ENGINE - STAGE 1 TURBINE NOZZLE ASSEMBLY - REWORK THE STAGE 1 HP TURBINE OUTER AIRSEAL ASSEMBLY TO IMPROVE COOLING AIR TO THE HP TURBINE - CATEGORY CODE 5 - MOD.ENG-72-0029

V2500-ENG-72-0029

## SERVICE BULLETIN

Location of Stage 1 HPT Seal Assembly and Stage 1 HPT Spacers  
Fig.1

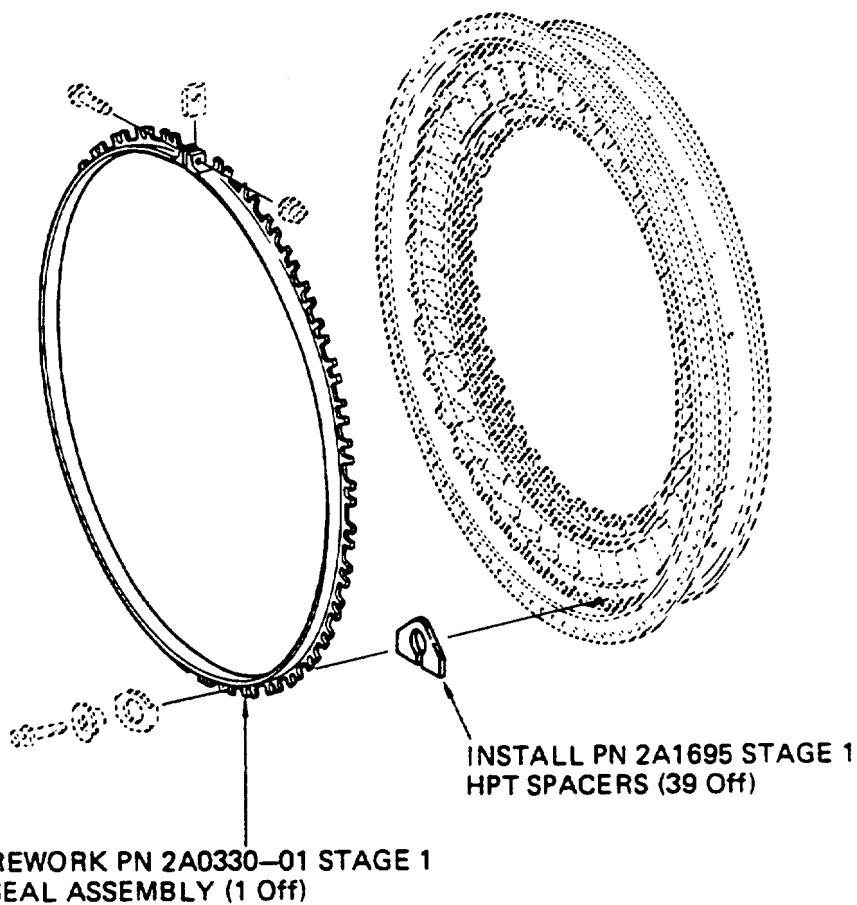
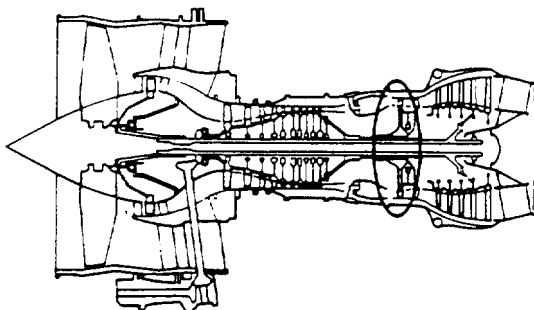
- (1) Do a modification on PN 2A0330-01 Stage 1 HPT Seal Assembly (1 off) and identify as PN 2A1980-01 as follows:

Procedure	Supplementary Information	
(a) Set-up and machine Surface G to obtain the dimensions specified	Refer to Figures 1 and 2	
(b) Identify with the new part number adjacent to the existing part number. Use the vibration peen method	Old Part Number	New Part Number
	2A0330-01	2A1980-01
	Refer to Figure 2. Refer to Reference (3). Control No./Task No.70-09-00-400-501

Install the Stage 1 HPT Seal Assembly and Stage 1 HPT Spacers  
Fig.3

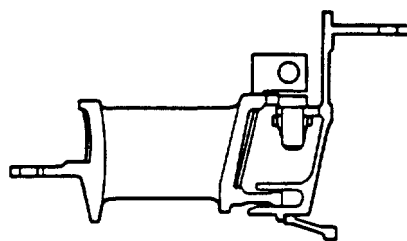
(g) Do a check of the clearance between the Stage 1 HPT Seal Assembly and the Stage 1 HPT Vane at 39 locations. Refer to Figure 3.

(h) If the clearance measured in step (g) is not from 0.024 to 0.050in. (0,61 to 1,27 mm) make sure the Stage 1 HPT Spacers are installed correctly.

0.024-0.050  
(0,61-1,27)  
CLEARANCE  
(39 Places)
